FENCE PERMIT

GRAND JUNCTION PLANNING DEPARTMENT

BLDG ADDRESS: 863 Colorado Ave

* PLOT PLAN

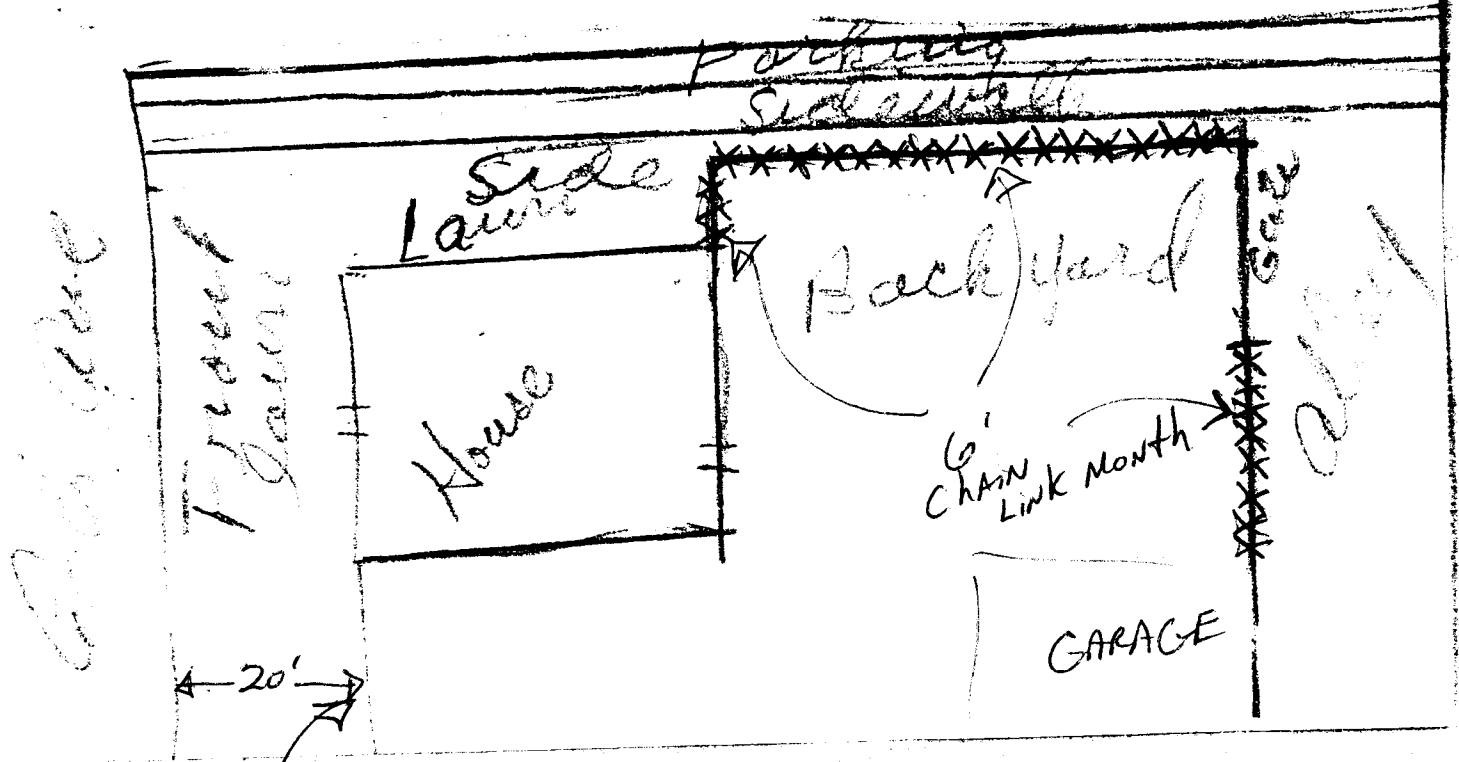
If this distance is not 20' from property line the chain link fence can only be 4' high.
